CITY OF ALBUQUERQUE

Planning Department
Alan Varela, Director

Re: Sandia Mechanical Office Warehouse
2731 Vassar PI NE
Traffic Circulation Layout
Architect's Stamp 12-01-23 (G16-D082B4)

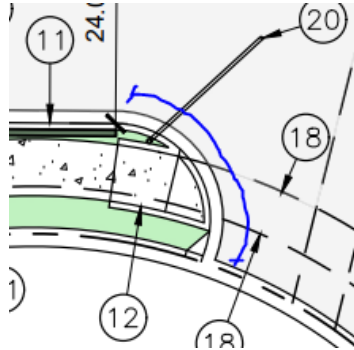
10. Provide the radius shown in the figure.

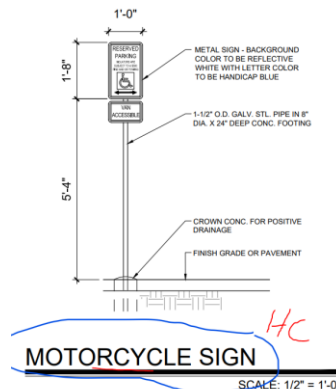
11. It is not apparent what type of pavement surface is being proposed. A hard driving surface will be required as part of this proposed project for parking area and drive aisles.
12. Provide the hatch legends.
13. The labels for HC sign and motorcycle sign has been swaped in the plan. Correct them.
